Ngā Ūranga ki Pito-One Shared Path

30% Detailed Design

5 September 2022

Figure 2: Example of the existing layout with visual delineation demarcating the pedestrian and cycle movements

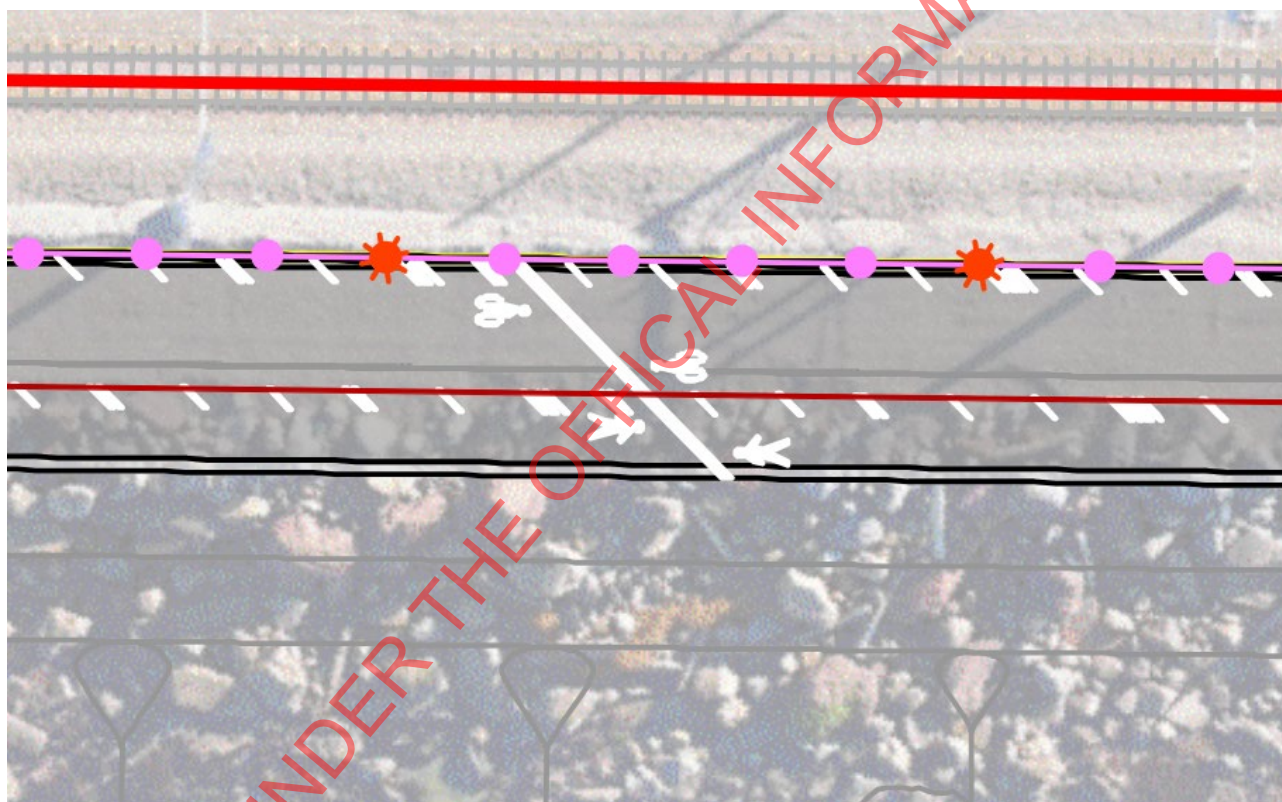
The pathway width is proposed at 4-5m which will accommodate general movements for people walking, cycling, passing and riding/ walking in pairs. The pathway should be able to provide adequate space for peak flow cyclists during the work week. However, at the weekend, users will likely be more sporadic and could typically be groups or families riding together. This creates a need for greater space for passing manoeuvres.

The preliminary drawings identify the pathway will be split with visual cues provided to demarcate separation between people walking and people cycling. During the project briefing the design team highlighted that a delineation strip was being provided to provide the visual separation, however, material choice has not yet been confirmed. It is conceptually shown as a directional tactile paver with painted hatching (or similar) which will provide a colour and texture difference.

The proposed pathway width could present risks of groups of walkers 3-4 abreast overlapping the cyclepath and may cause friction with cyclists as they protrude into the cycle path.

It is recommended that an option to provide a full, shared path with no delineation along with behavioural influencing signage and marking to reduce friction between users.

It is also recommended that the disability sector is consulted about the use of tactile pavers along the length of the route.

Figure 3 Uranga layout requires further demarcation of movement vs. seating areas

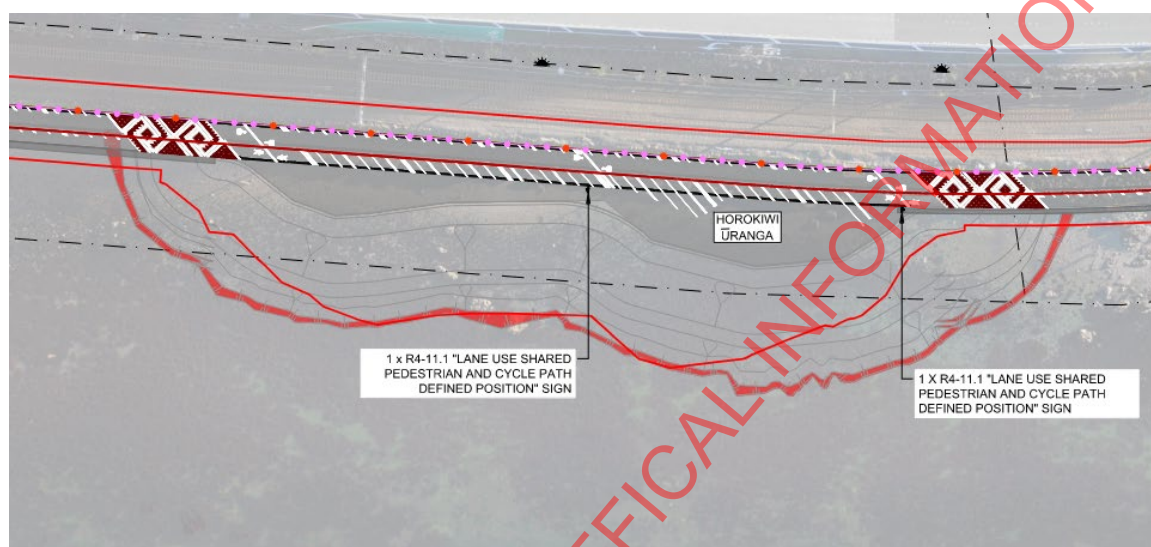
There are 6 proposed Uranga sites spread along the route which provide great amenity for path users. These areas provide seating, lookout and artwork which tell a story of the place. This will enhance the journey experience and enable people to stop, rest and gain knowledge before continuing along the route. Due to the length of the route the safety audit team questioned whether there were opportunities to integrate more secondary pause points (ie. Seating/ small stopping areas) to allow further opportunities for people to stop and rest along the journey. These sites will also be very popular destinations at the weekends for recreational users and require adequate space for movement as well as passive recreation.

Some Uranga sites are larger and have the ability to accommodate a walkway that is separate from the main shared path. This will provide relief from cyclists for pedestrians and enhance the separation of the modes.

Proposed Uranga layouts should be considered to ensure people walking and cycling can easily access these rest areas. This includes placing bike racks away from main access points and allowing for a clear differentiation between movement paths and passive zones through the area.

Consider if there are further places to integrate additional street furniture or smaller seating areas along the journey to increase opportunities for people to stop and rest.

Consider opportunities to utilise the larger Uranga sites to create a meandering pedestrian only path that enables people walking to be actually separated from cycle conflicts for some short sections.

Figure 5 Circled intersection for wayfinding required to enable clear directions for path users

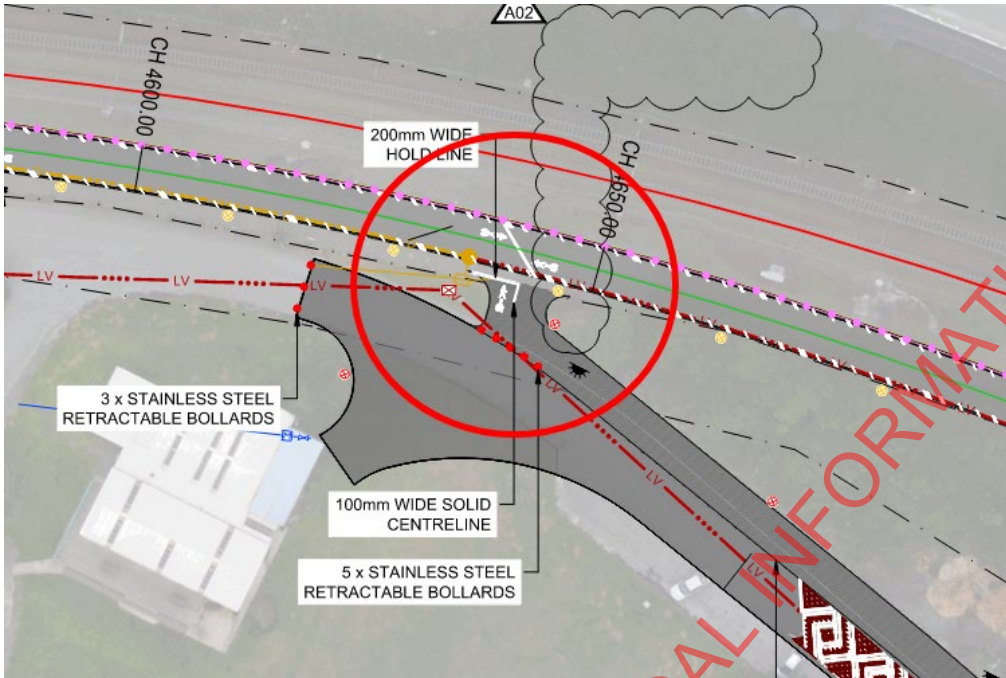
There is no wayfinding signage indicated on the plans. Consider providing wayfinding signage, map boards and signs highlighting distance to key destinations. A critical area for wayfinding includes at the Y junction in the shared path to both Hōniana Te Puni Reserve and Hutt Road.

Figure 6 KiwiRail Maintenance Bay located at CH2950m

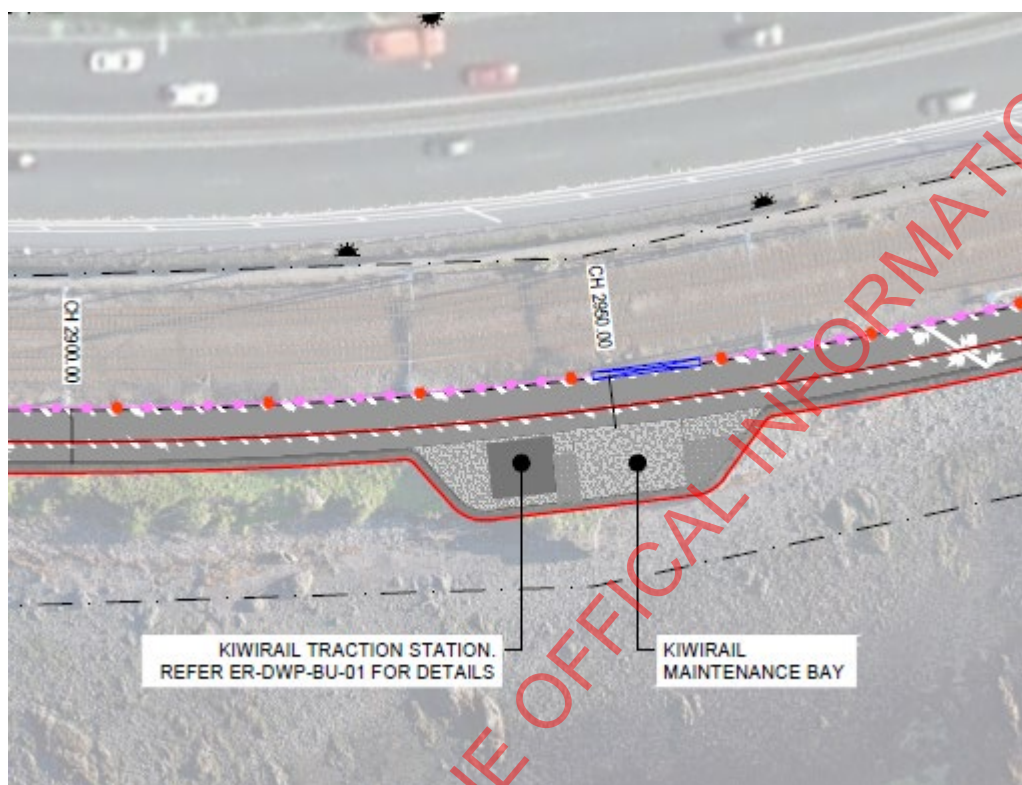
The existing KiwiRail Traction station shows a maintenance bay where vehicles are likely to park up during times of maintenance. This may cause conflict with shared path users.

Install appropriate warning signage and markings for both shared path users and KiwiRail staff. Implement a Health and Safety protocol for all KiwiRail Staff the entire length of the shared path for maintenance purposes. The adjacent KiwiRail access gate should remain locked at all times and regularly checked that it is so.

Figure 7 Maintenance Bay located at CH880m

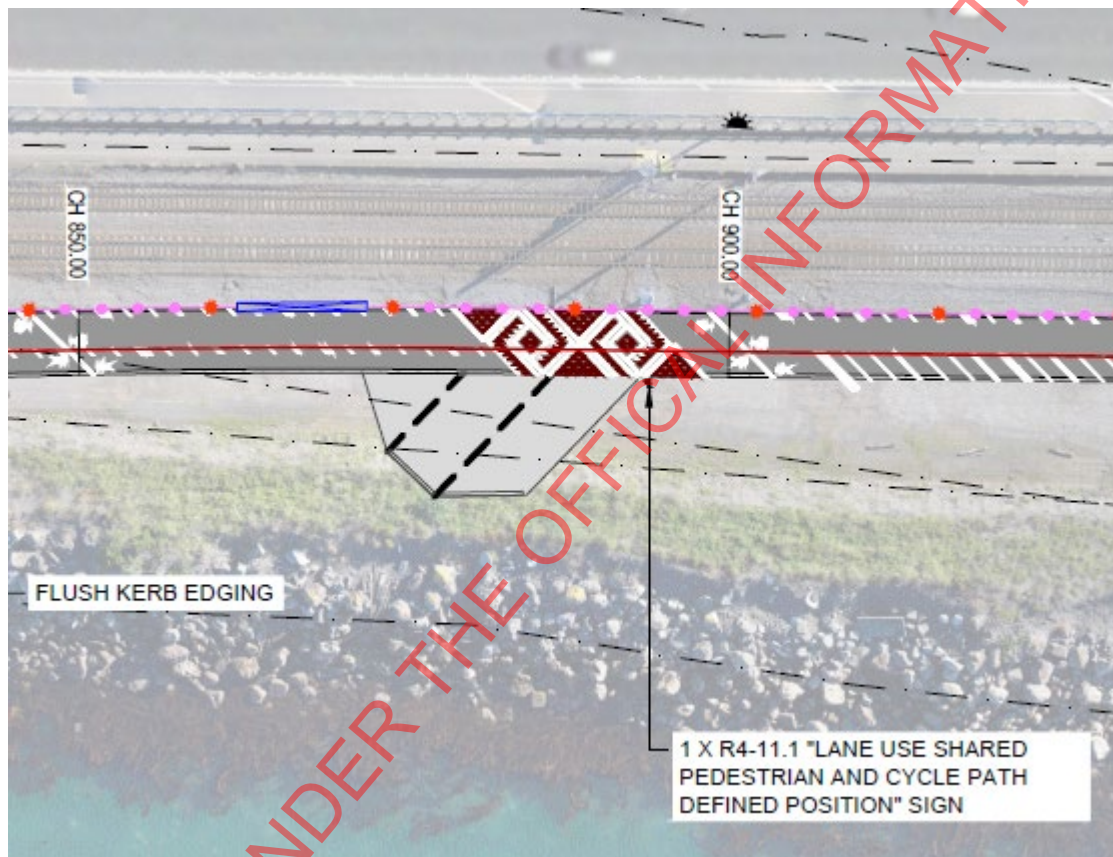
There are a number of maintenance bays for maintenance vehicles to park along the route. These areas have the potential to cause conflicts between vehicles and shared path users

Install appropriate warning signage and markings for both shared path users and maintenance bay users. Implement a Health and Safety protocol for all maintenance crews for the entire length of the shared path for maintenance purposes. The adjacent KiwiRail access gate should remain locked at all times and regularly checked that it is so. This should be the case for all KiwiRail access gates along the route.

Figure 9: Cyclepath crossing over KiwiRail Access Lane.

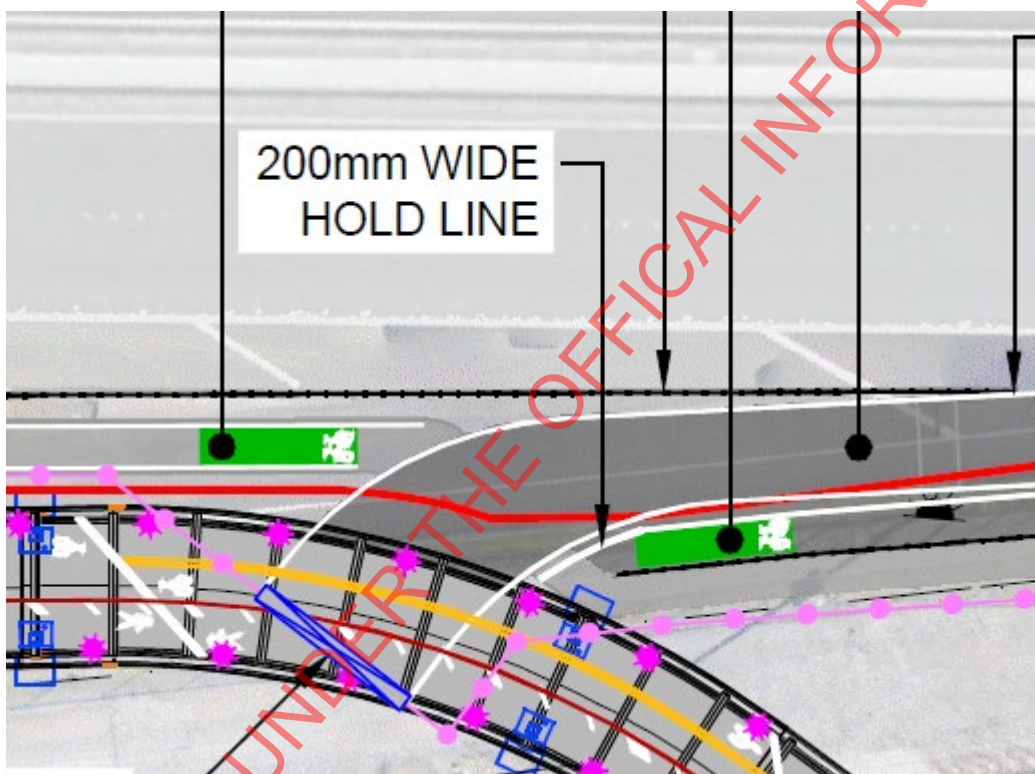
The access from the SH2 shows a formal cycleway with green markings which crosses the KiwiRail access lane. This may tend to encourage cyclists (especially the high speed cyclists) not to use the new shared path and to use the SH2 shoulder all the way from Petone to Ngauranga. We believe that this access should be a last resort only cyclepath and only if cyclists find themselves on SH2 and need to exit.

- that this access from the shoulder be a subtle (i.e. last resort) exit.
- Include appropriate signage installed at the Northern end of SH2 that encourages all cyclists to use the shared path and not SH2 as well as appropriate signage to indicate to any cyclists on SH2 that they must exit at this location before going onto the Thorndon Quay raised motorway.
- Include appropriate design elements to avoid conflict between KiwiRail users and cyclists such as giveaway and warning signage and markings.
- It is recommended that the movement path for cyclists across the access lane should be at 90 degrees to the vehicle movements. An example of this layout is shown in Figure 9.

Figure12: Area where there is opportunity to separate the shared path from the access lane.

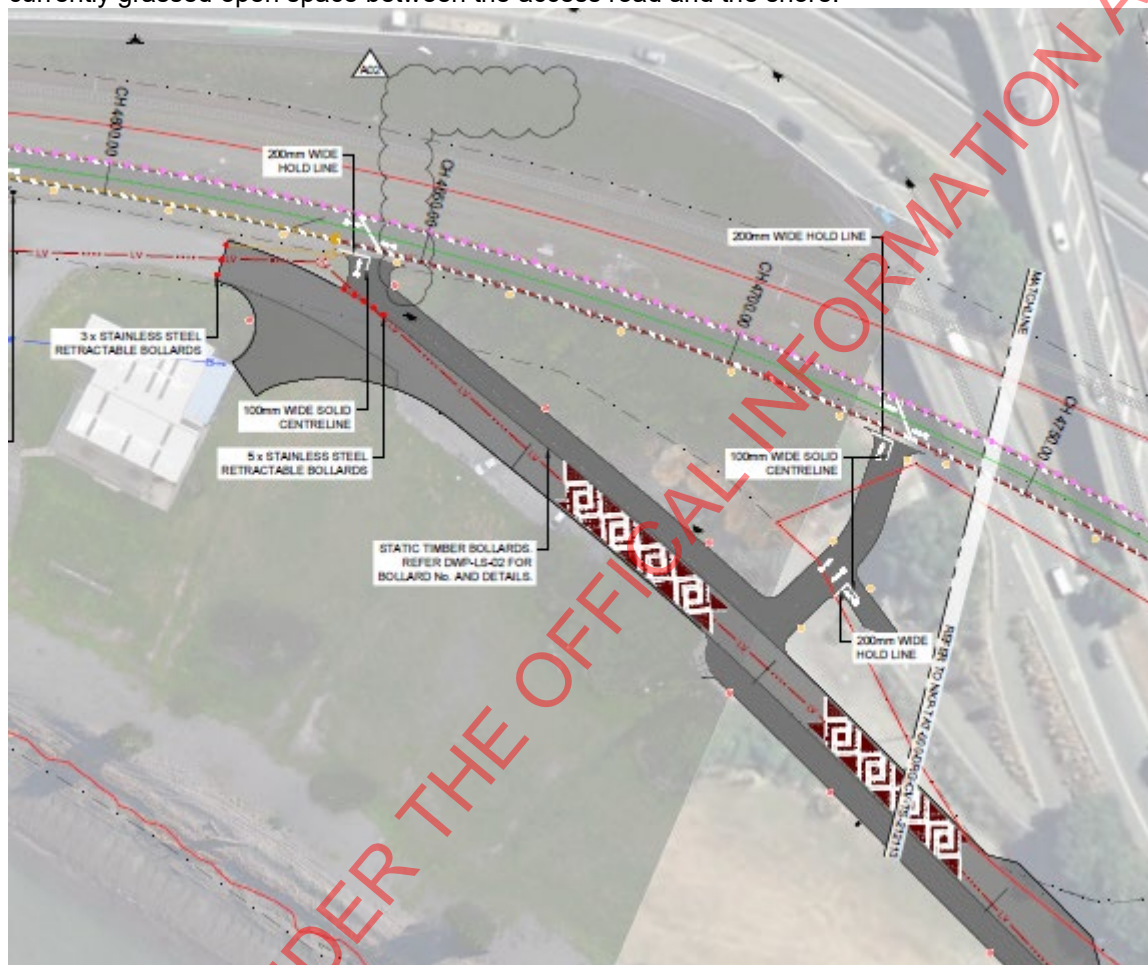
The shared path has been designed hard against the Access Road to the Water Ski club in the area to the west of the Korokoro bridge and South of the Water Ski Club Buildings. However, there is opportunity here to fully separate the shared path from the access road by creating a meandering path through the large currently grassed open space between the access road and the shore.

Separate the shared path from the access lane through this large open space area. There is also an opportunity in this area to separate the cyclists from the pedestrians. Possibly consider a separate bridge for the shared path users also to further increase safety measures.

Figure 14: Boat Ramp area with very limited turning space.

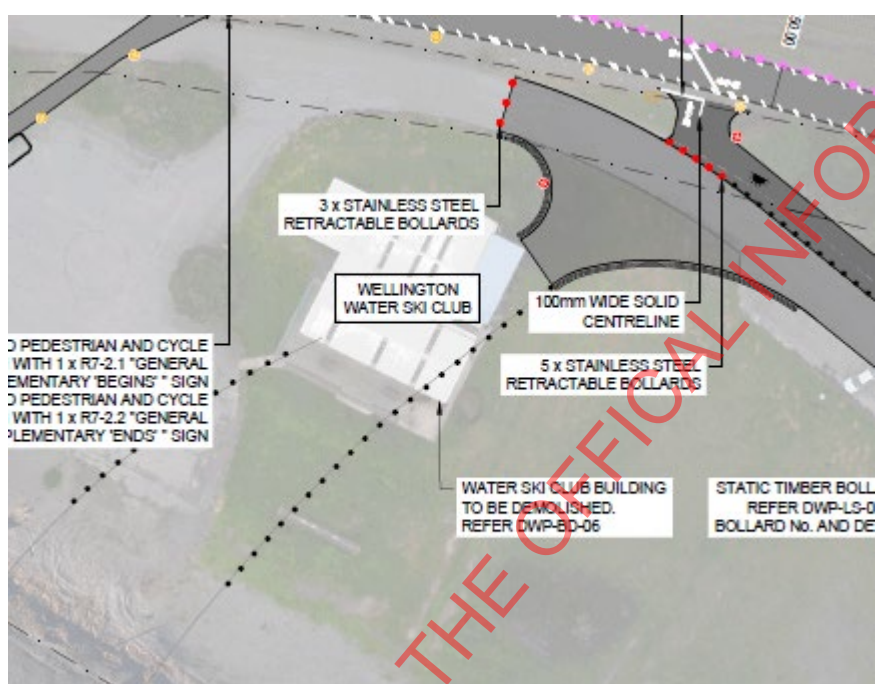
The proposed boat ramp access appears to have limited area for car and trailers to make turning and reversing manoeuvres. Vehicles with boat trailers (especially rowing skiffs) require large amounts of turning space to access the boat ramp. Providing a reduced area for manoeuvring could create issues with conflict with other vehicles and shared path users.

Consider the design and layout of the boat ramp access and provide sufficient turning areas for vehicles and boat trailers / staging areas. Consider long skiff trailers when designing the area.

Figure 16: Shared path crossing at boat access road

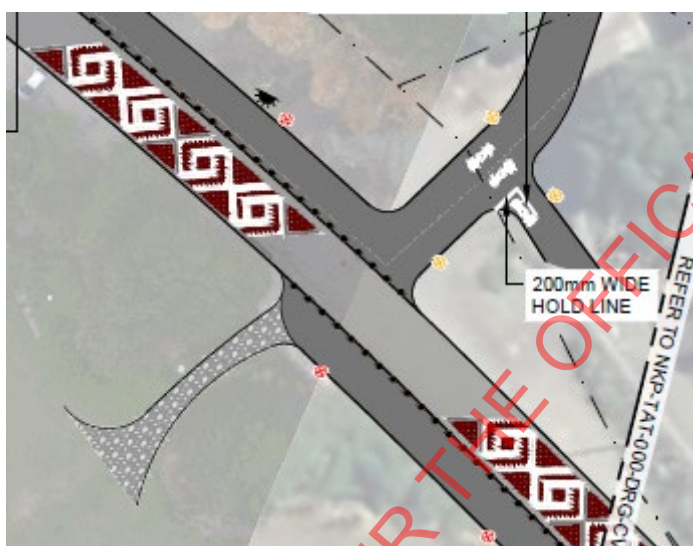
This area is a conflict zone with the different users including vehicles on the access lane, cyclists and walkers on the hazard path and other users within the park area itself. This area has potential to cause collisions between all the users.

Provide traffic calming measures and bollard placement to enable a seamless journey for both pedestrians and cyclists. It is recommended that the option is explored to include a raised platform across the access road to retain the shared path at one level. A raised platform will also encourage slower speeds by car drivers.
